Access Compliance Report

Public Rights-of-Way (Curb Ramps)

Intersection ID: 6889	Main Street: GRIERS GROVE RD	Cross Street: PLUMSTEAD RD	Location: W
ADA ID: 815B9CFE159B	Ramp Type: Para	Initial Pass/Fail: Fail	Overall Compliance: No
Codes/Mitigation Info/Possible Solution		Field Measurements/Component Compliance

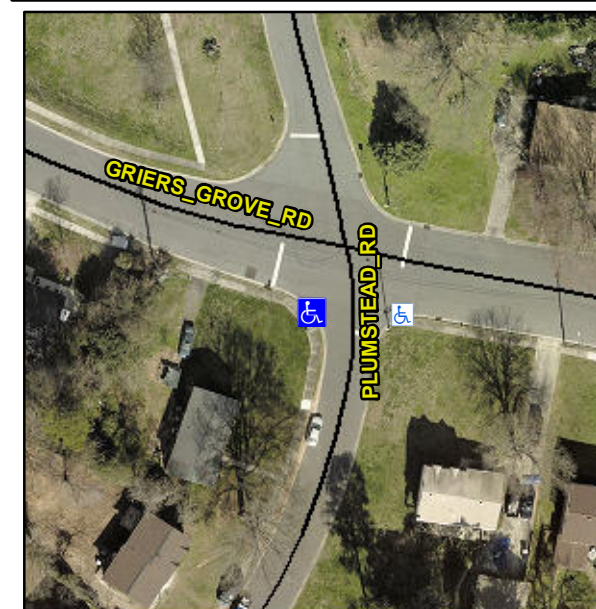
RT RP < 5%

R304.3.2, R304.5.3

Compliance	Description	Data	Compliance	Description	Data
N/A	Ramp Length LT (in)	56.5	N/A	Ramp Length RT (in)	58.0
Yes	Ramp Width LT (in)	60.0	Yes	Ramp Width RT (in)	76.0
No	Ramp Slope LT (%)	10.2	Yes	Ramp Slope RT (%)	2.1
No	Ramp XSlope LT (%)	3.6	Yes	Ramp XSlope RT (%)	1.3
N/A	Landing Length (in)	N/A	N/A	DWS Provided?	N/A
N/A	Landing Width (in)	N/A	N/A	DWS Contrast?	N/A
N/A	Landing Slope (%)	N/A	N/A	DWS Length (in)	N/A
N/A	Landing X Slope (%)	N/A	N/A	DWS Full Width?	N/A
N/A	Landing Curb? (Y/N)	N/A	N/A	DWS Offset (in)	N/A
N/A	Shared Landing?	N/A			
N/A	Gutter Ponding?	N/A	N/A	Gutter Slope (%)	N/A
N/A	Gutter Lip Ht (in)	N/A	N/A	Gutter X Slope (%)	N/A
N/A	Painted X Walk1?	No	N/A	Painted X Walk2?	N/A
	X Walk 1 Direction	To E		X Walk 2 Direction	N/A
N/A	X Walk 1 Width (in)	N/A	N/A	X Walk 2 Width (in)	N/A
	X Walk 1 Slope (%)	5.8		X Walk 2 Slope (%)	N/A
	X Walk 1 X Slope (%)	1.4		X Walk 2 X Slope (%)	N/A
N/A	Ramp inside XWalk1?	N/A	N/A	Ramp inside XWalk2?	N/A

Remove & Replace Entire Ramp.
